Service Bulletin

Subject: Whistle Noise Heard from Engine Compartment, Rough Idle and/or DTC P0171 Set

Models: 2011-2012 Chevrolet Cruze
Equipped with 1.4L Engine (RPO LUJ)

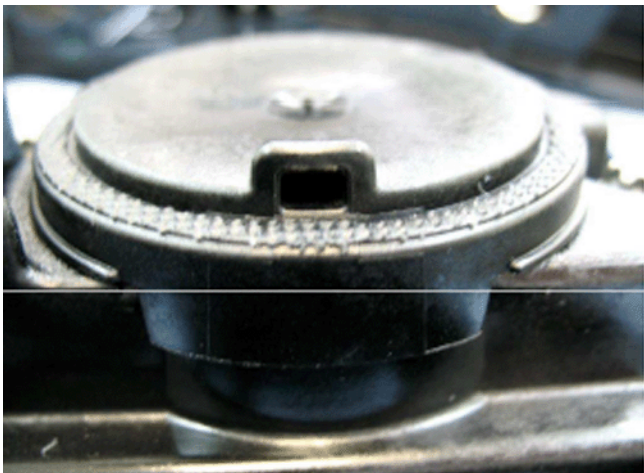
Some customers may comment on a whistle noise heard from the engine compartment and/or the vehicle runs rough with the service engine light on.

This may be caused by a vacuum leak in the positive crankcase ventilation (PCV) located on the camshaft cover.

Note: The old style camshaft cover has a taller design PCV cap as shown in the illustration above.

Note: The new design camshaft cover has a flatter/lower cap as shown in the illustration above.

With the engine running using your finger, place it over the breather port of the PCV diaphragm to see if the whistle noise goes away and/or the fuel trims are high then return to normal levels.

If the noise goes away, replace the camshaft cover and clear the DTC.
